TECHNICAL NOTE

File Ref: NP/CS/P21-2187/03TN

Subject: Grant Family – Deadline 2 Response

Appendix A Fordley Road Link Options

Figure 2.1 – Site Context

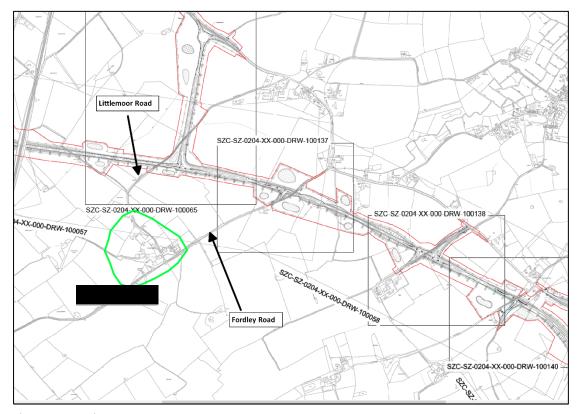
- 2.3 The location of Fordley Road and Littlemoor Road, in relation to (Grant family home) is shown on Figure 2.1 below. The Hall and associated buildings form a working farm and rely heavily on the connection to the B1122, Middleton and other surrounding villages.

Figure 2.2 – Dissected by SLR

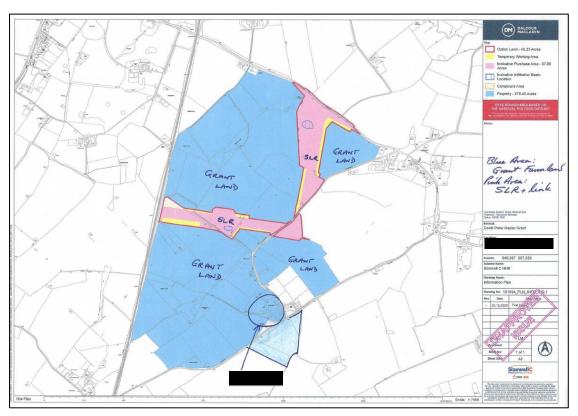
- 2.5 Figure 2.2 below shows how the proposed SLR dissects ; the resultant loss of acreage, 15% of the total arable area, and severance will impact negatively in the farm's viability.

- The closure of both Fordley Road and Littlemoor Road offers no direct connection from 50% of the Grant's farming operations to other land parcels north of the SLR.
 The Grant family and all other residents along Fordley Road are completely severed from important village facilities at Middleton, such as the Church, farm shop, pub and other important community services.

- The closure of Fordley Road and Littlemoor Road completely restricts the Grant's ability to access their farmland without lengthy diversion, road registration or even replacement of farm vehicles and equipment will be essential and add considerably to costs. The water supply for the farm's sprayers is located close to the B1122 north of the SLR. The Applicant has not engaged to offer mitigation solutions.

OPTION A - INDICATIVE LONG SECTION

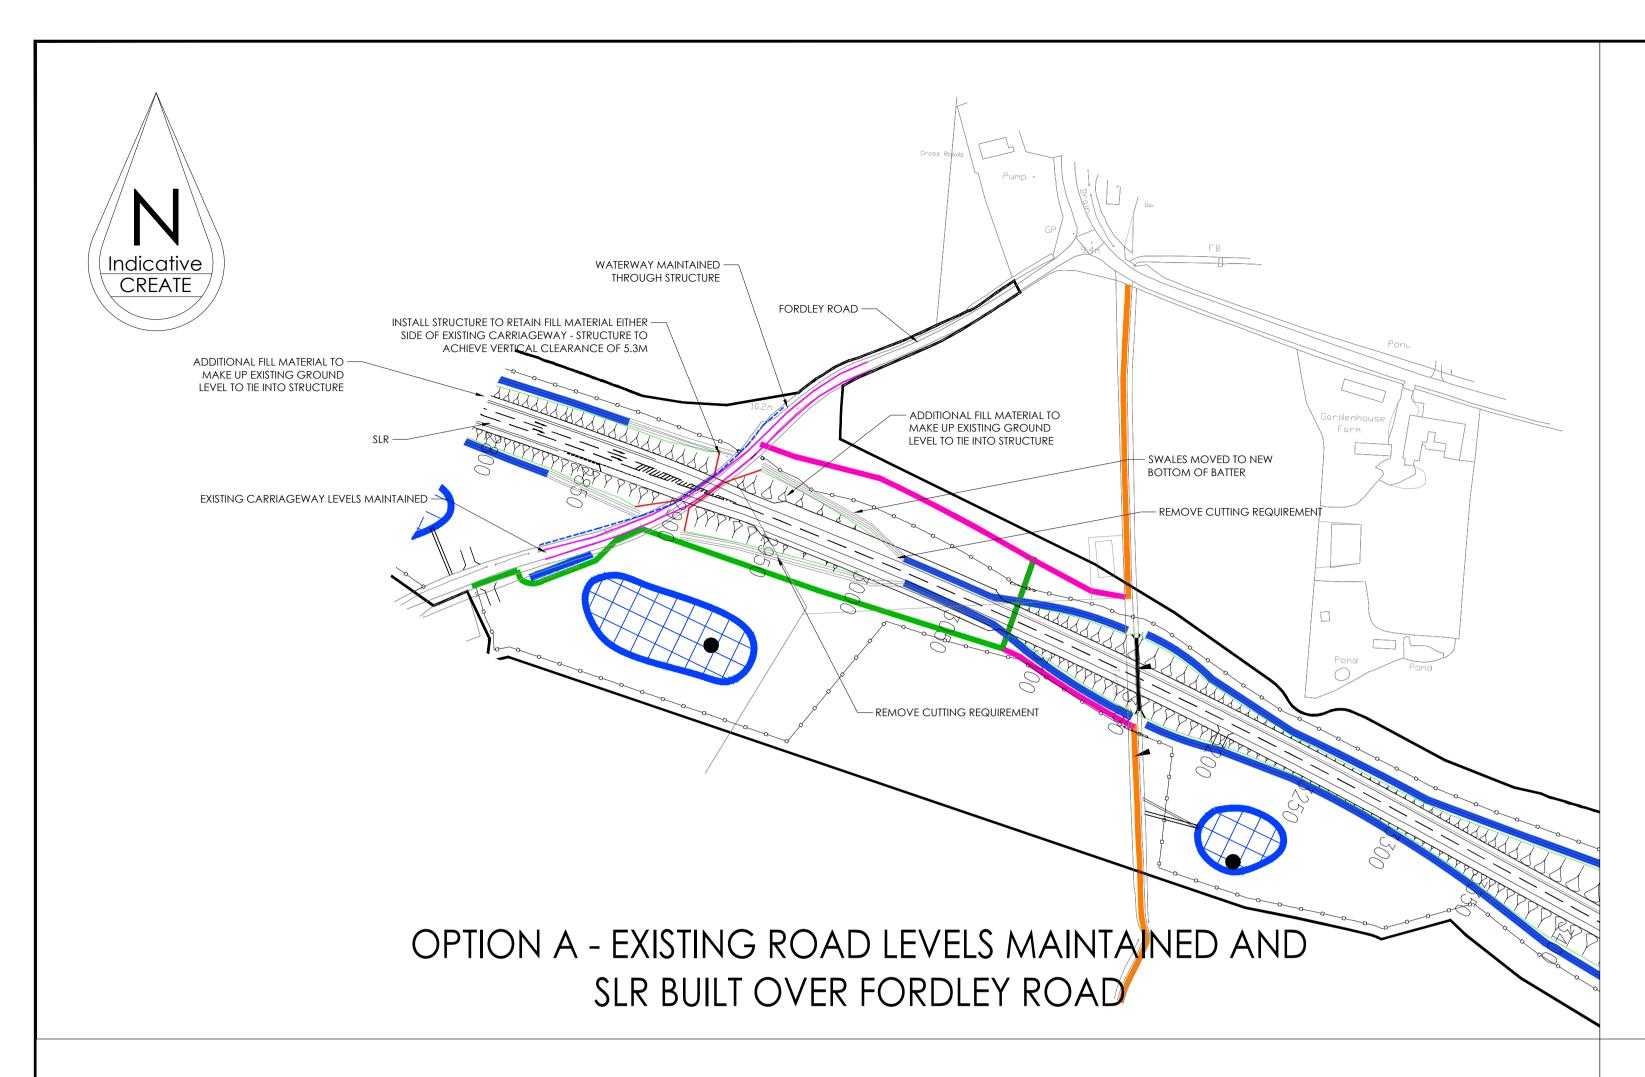
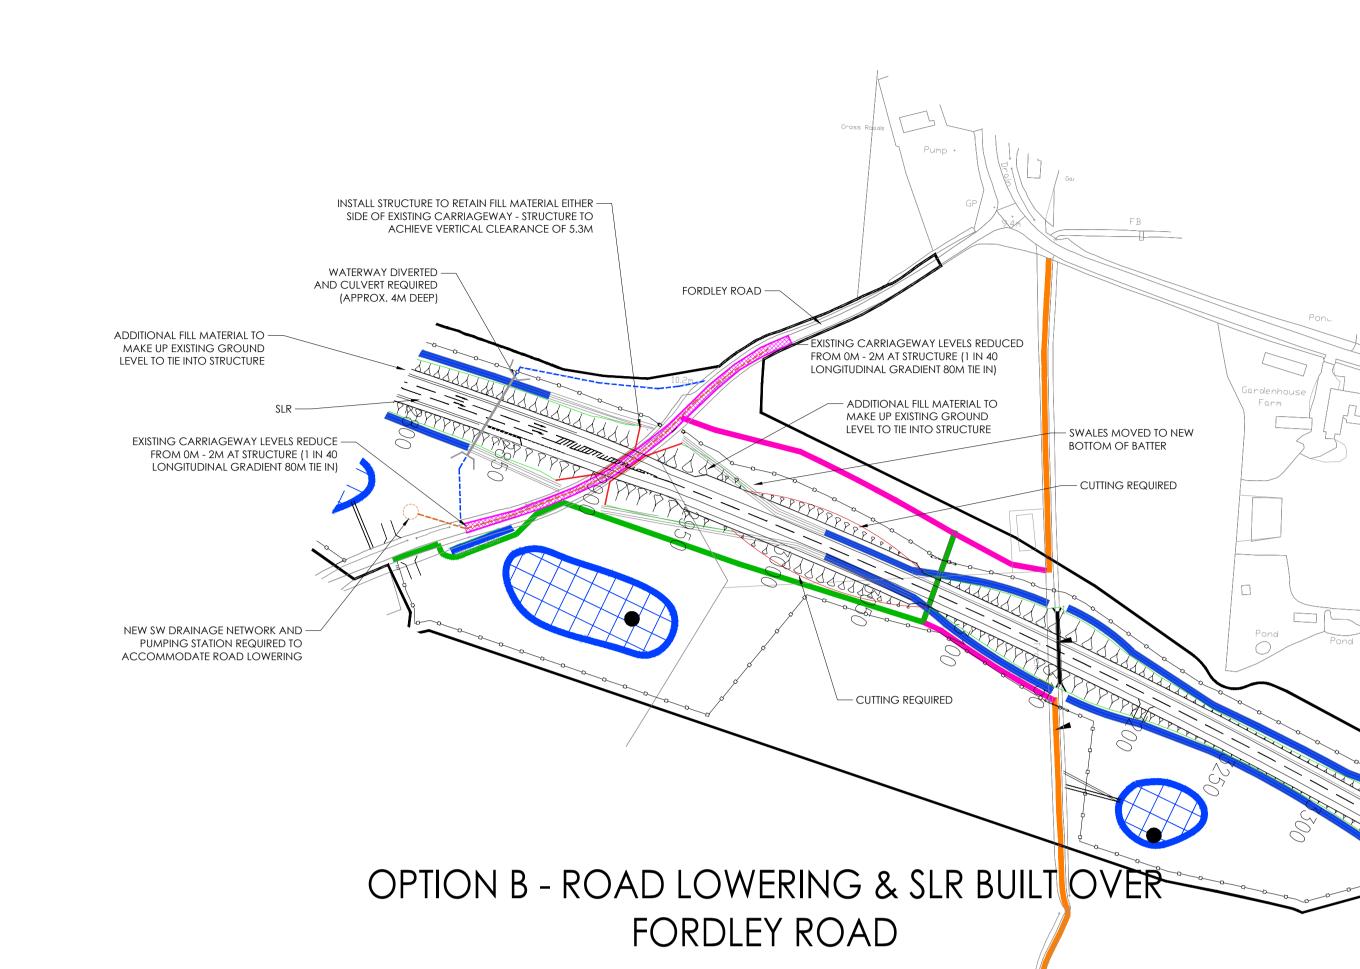
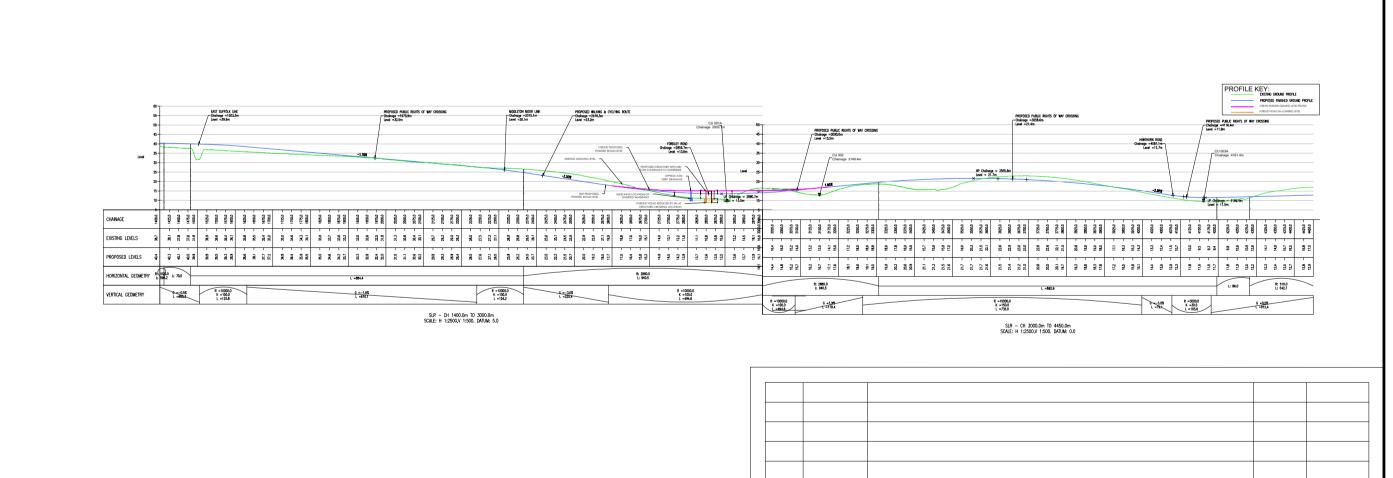
Fordley Road Options	Details	Proposals
Option A – Maintain current finished road levels.	Maintain the existing road level of Fordley Road, build up ground profiles either side of the road and construct a structure over the road with 5.3m clearance to mitigate the need to permanently close off Fordley Road at the junction with the Sizewell C Link Road (SLR).	 Maintain full north / south access on Fordley Road No need to construct a new 100m long slip road as per EDF proposal No need to construct turning head on EDF proposal No need to divert waterway as per EDF proposal Tying into existing elevated ground levels approx. 100m/200m either side of the structure (see magenta line on long section). Remove cutting between CH 3075 & CH 2940 Additional filling required between CH 3000 & CH 2660 Up to 3.5m fill above EDF proposed FRLs (but fits in with ground profiles either side) 5.3m clearance structure / abutments and wingwalls required Traffic flow could be maintained throughout project duration (short closure to lift / construct structure) Existing drainage network could be maintained Eliminate need for turning traffic / HGVs from Fordley Road onto SLR – therefore increased safety for Fordley Road Traffic

Option B – Lower Fordley Road by 2m.	Lower Fordley Road by 2m at the junction with the SLR and construct a structure with 5.3m clearance to mitigate the permanent closure of Fordley Road north/south access. Ground profiles to be built up either side of the road.	 Less fill earthworks than Option A but would require cutting between CH 3075 – CH 2975 Fill earthworks required either side of structure to build up ground profiles Maintains full north/south access on Fordley Road No need to construct a new 100m long slip road as per EDF proposal No need to construct turning head on EDF proposal Traffic flow not able to be maintained during construction due to road lowering (unless build adjacent to current road offline) 5.3m clearance structure / abutments and wingwalls required Surface water network will be installed to accommodate lower levels and possible flood prevention Pumping station likely needed to control surface water (electrical supply and outfall to be source) Waterway will require diverting (approx 4m deep drainage beneath SLR) Approx. 160m of carriageway to be lowered to 2m at lowest point to meet acceptable longitudinal highway gradients Eliminate need for turning traffic / HGVs from Fordley Road onto SLR – therefore increased safety for Fordley Road Traffic

Current EDF Proposal	Cut off Fordley Road at the junction with the SLR and make access to the north of the SLR redundant from Fordley Road. Diversion requiring a 2km diversion route to access north side of Fordley road.	 Cut off Fordley Road north of SLR 2km diversion route created requiring northbound or southbound Fordley Road traffic to use SLR to access north side of Fordley Road Cut and fill earthworks to build up ground profile Earthworks to build up slip road Divert waterway beneath SLR Construct a turning head north side of Fordley Road to allow traffic to turn around Cut off traffic flow along Fordley Road during construction phase

- 2.12 As a result, Create and the Grant family request that the Applicant reconsiders the Fordley Road link and remove any connection with the SLR, thus retaining Fordley Road for local traffic use only.
